REFERENCE: Groundwater Registration Modification Application T-13940

In the Matter of Groundwater	)	FINAL ORDER APPROVING
Registration Modification Application	)	RECOGNITION OF ADDITIONAL POINTS OF
T-13940, MARION County	)	APPROPRIATION AND MODIFICATION IN
	)	PLACE OF USE

Groundwater Registration Modification T-13940

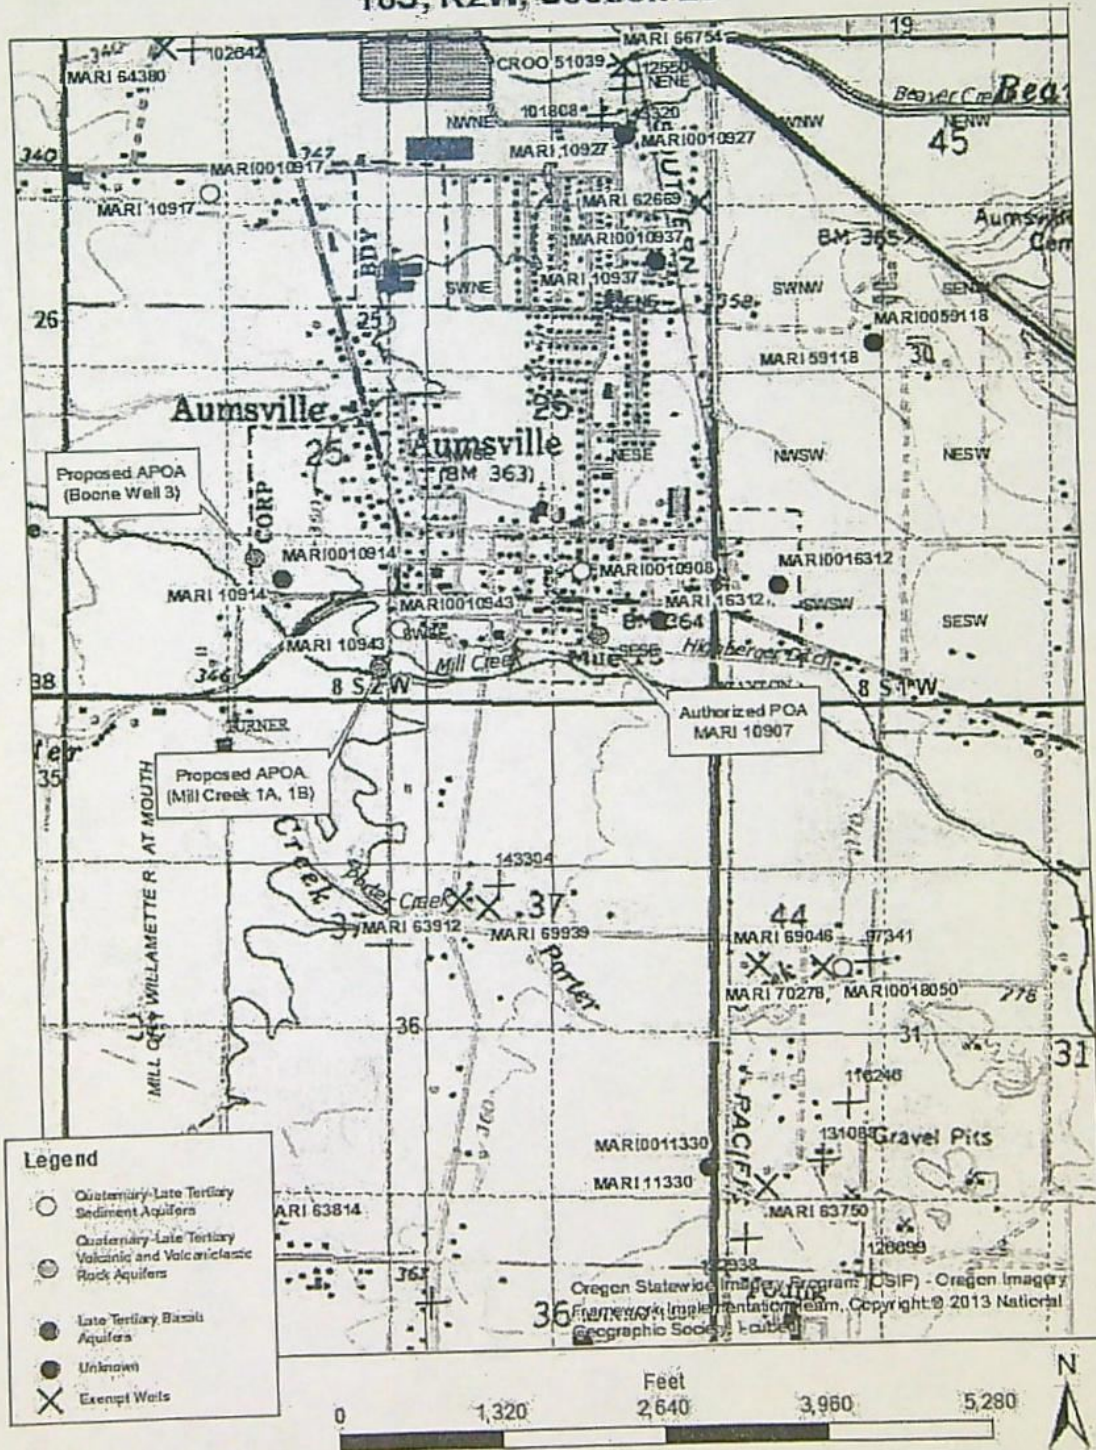
The proposed construction for all three APOA shows two planned perforated or screened intervals: 80-100 ft bls and 140-190 ft msl. These intervals are all deeper than the likely water-bearing zone interval in the authorized POA MARI 10907 (total reported depth of only 75 feet), but will obtain groundwater from the same alluvial aquifer system.

The groundwater review for related transfer application T-13938 (completed 1/12/2023) recommended modifications to the proposed construction for these same three APOA to mitigate potential impacts to Mill Creek. Thus, to be consistent with the recommendations presented in the T-13938 review, the same following recommendations are presented here:

In order to mitigate potential impacts to Mill Creek, the following changes to proposed construction for the three APOA are recommended:

- a) Eliminate the upper perforated or screened interval planned between 80-100 ft bls.
- b) Extend the surface casing and sealed interval from ground surface to approximately 100 ft bls, or about elevation 250 ft msl (which is 25 feet deeper than the currently proposed seal depth).

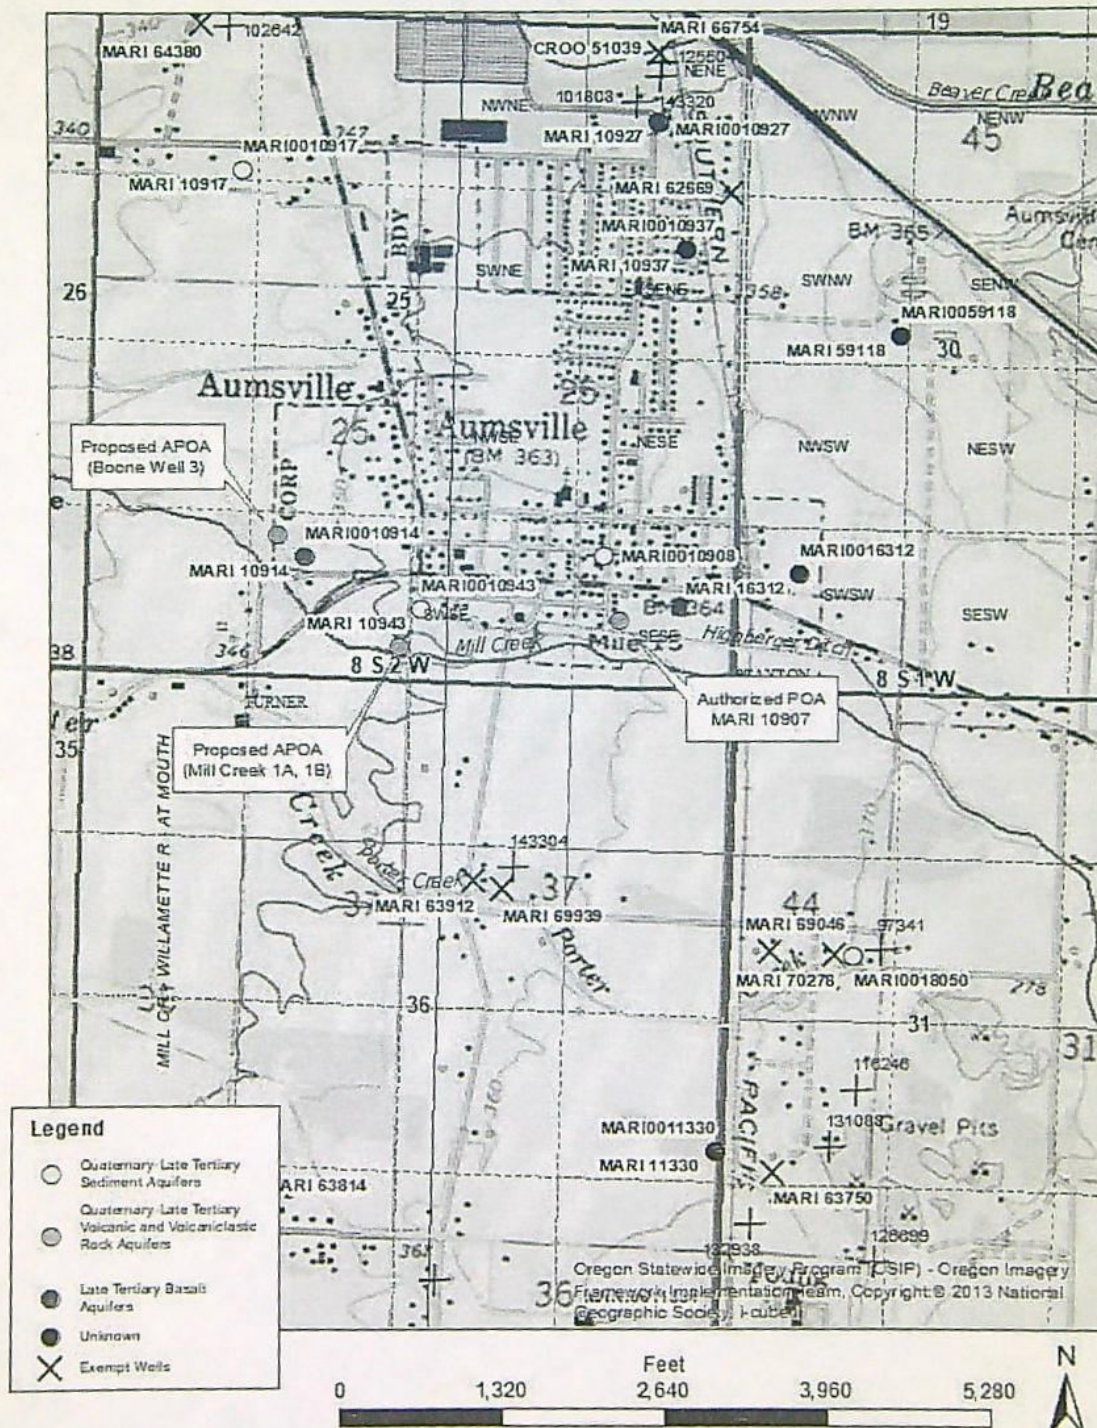
The proposed construction for all three APOA shows two planned perforated or screened intervals: 80-100 ft bls and 140-190 ft msl. These intervals are all deeper than the likely water-bearing zone interval in the authorized POA MARI 10907 (total reported depth of only 75 feet), but will obtain groundwater from the same alluvial aquifer system.

The groundwater review for related transfer application T-13938 (completed 1/12/2023) recommended modifications to the proposed construction for these *same three APOA* to mitigate potential impacts to Mill Creek. Thus, to be consistent with the recommendations presented in the T-13938 review, the same following recommendations are presented here:

In order to mitigate potential impacts to Mill Creek, the following changes to proposed construction for the three APOA are recommended:

- a) **Eliminate the upper perforated or screened interval planned between 80-100 ft bls.**
- b) **Extend the surface casing and sealed interval from ground surface to approximately 100 ft bls, or about elevation 250 ft msl (which is 25 feet deeper than the currently proposed seal depth).**
